REED COLLEGE
REED RESEARCH REACTOR
LICENSE NO. R-112
DOCKET NO. 50-288

RESPONSES TO THE
REQUEST FOR ADDITIONAL INFORMATION
DATED MAY 20, 2011

Docket: 50-288
License No: R-112
Subject: RAI TAC NO. ME1583, dated March 8, 2010.

Figure 1 Core k-effective vs. % moderator void

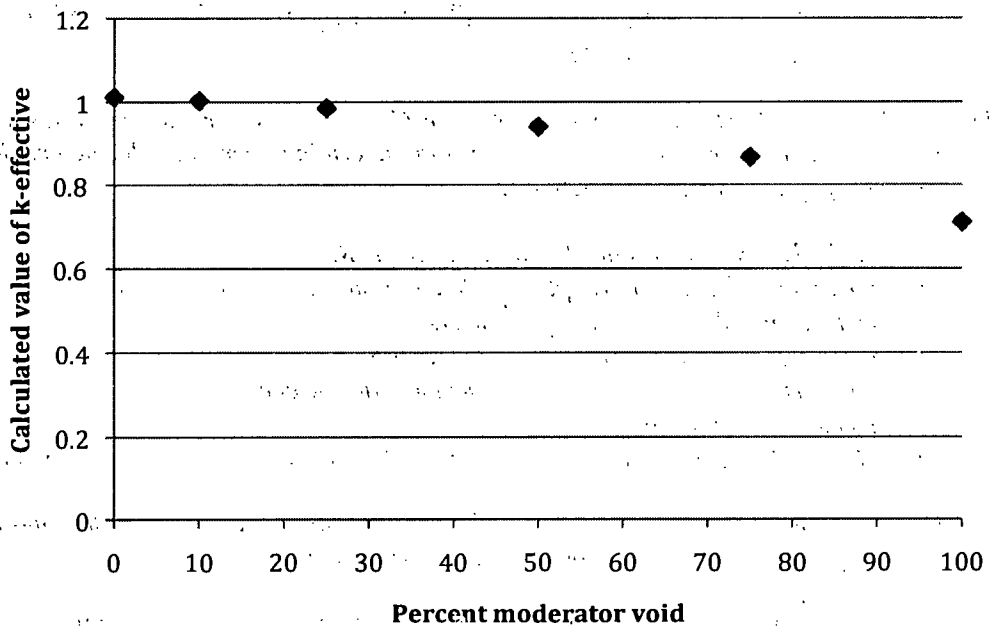
A question arose whether the calculated value for the void coefficient of reactivity is too large, especially when compared with calculated values from other similar facilities. Section 8 of Attachment A states that the average void coefficient over the range from 0% void to 100% void is $-\$0.83$ per percent void. This is very similar to the $-\$0.86$ value calculated for the OSTR and compares reasonably well with the measured OSTR value of $-\$0.51$ per percent void. As discussed below, it is highly improbable that the RRR could be operated with more than a few percent moderator void present in the core. The reactivity coefficient for the RRR within such an operating envelope is on the order of $-\$0.12$ per percent void.

Figure 1 shows k_{eff} vs. percent of moderator void. Removal of 100% of water from the core results in the introduction of \$54 negative reactivity. The graph indicates that removing any amount of water from the core will always result in the introduction of negative reactivity. The slope of the curve in terms of Δk per percent or \$ per percent increases with increasing percent void.

It is understood that in order to calculate a void coefficient one varies density while holding temperature constant. To calculate the void coefficient, we first calculated k_{eff} of the reactor with the in-core water moderator at nominal temperature and normal corresponding density. We then reduced in-core water density to 90% of the original value and re-calculated k_{eff} at the same temperature. This process was repeated with in-core water densities of 75%, 50%, 25% and 0% of the original densities. The resulting eigenvalues for each core state are tabulated below and plotted in Figure 1.

Figure 5 Reg Rod Worth for RRR Core

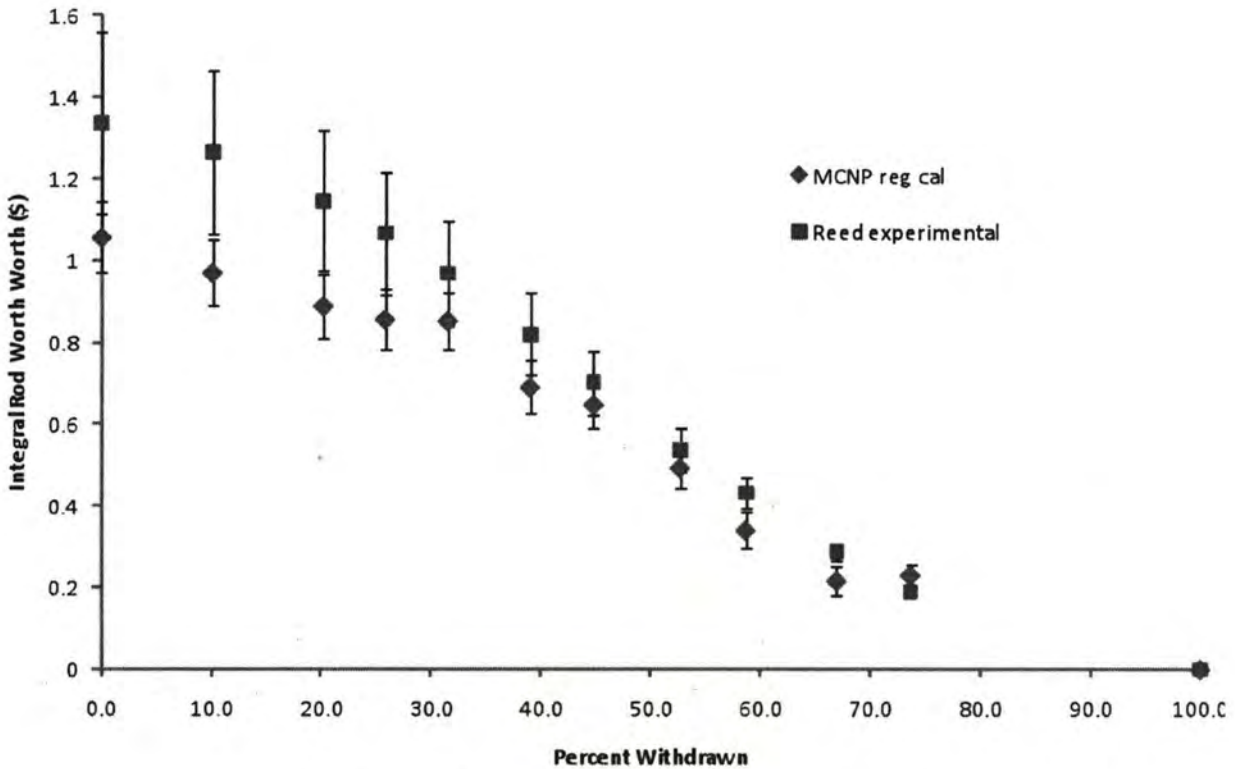
It has been noted that Figure 5 of Attachment A indicates that the calculated IRW value of the reg rod is \$1.06 and the measured value is \$1.34. Furthermore, some of the calculated reactivity values are non-physical, that is *withdrawing* the rod seems to introduce *negative* reactivity over certain increments. In response, during initial modeling attempts, it was found that the control rods in the MCNP model had a calculated worth that was significantly higher than the recent measured values. It was reasoned that not only had the fuel experienced some depletion, but the control rods had as well. In order to account for this, control rod boron content of the MCNP model was reduced as discussed in section 4 of Attachment A. All three control rods were depleted in exactly the same manner such that the calculated value of total rod worth was reduced to essentially the same value as measured total rod worth. Note, however, that the Reg rod is located in the E-ring while the other two rods are located in the C-ring. The reg rod is thus depleted significantly less than the other two rods. By depleting all three control rods in an identical manner, the end result was that the reg rod was significantly over-depleted and the shim and safe rods were slightly under-depleted. The goal of the depletion simulation was to achieve good agreement between measured and calculated total rod worth. A more accurate approach would have been to deplete each control rod in such a manner that the calculated and measured worth of each rod would be equal. Although this is a flaw in the model, safety calculations that involve control rod accidents are based on the *most* reactive rod sticking or ejecting. Values used in these safety calculations were based on measured rod worth, not calculated rod worth.
